B1505A-02

Modification Recommended Service Note

B1505A Power Device Analyzer/Curve Tracer Mainframe

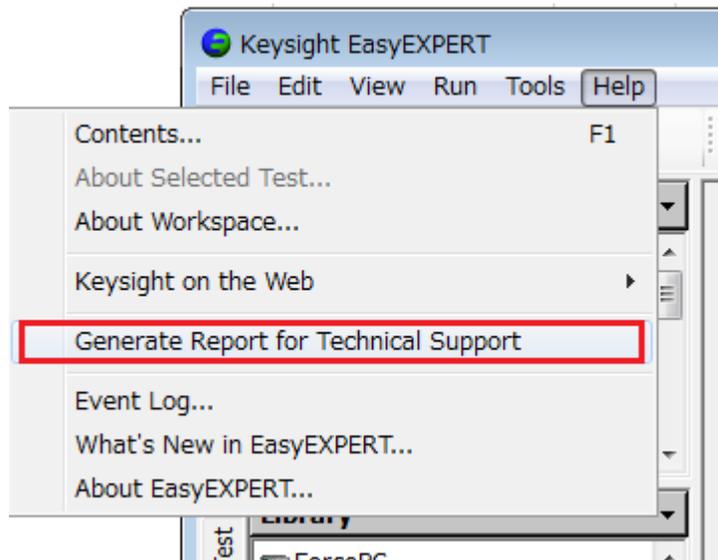
- (a) Confirm the B1505A serial number if it is listed on the page 4. If listed, proceed to (b).
- (b) Confirm the EasyEXPERT and the firmware revision as follows and check against the table above.
 - Step 1: Start the EasyEXPERT software.
 - Step 2: Click “Help” and select “Generate Report for Technical Support” as shown below.
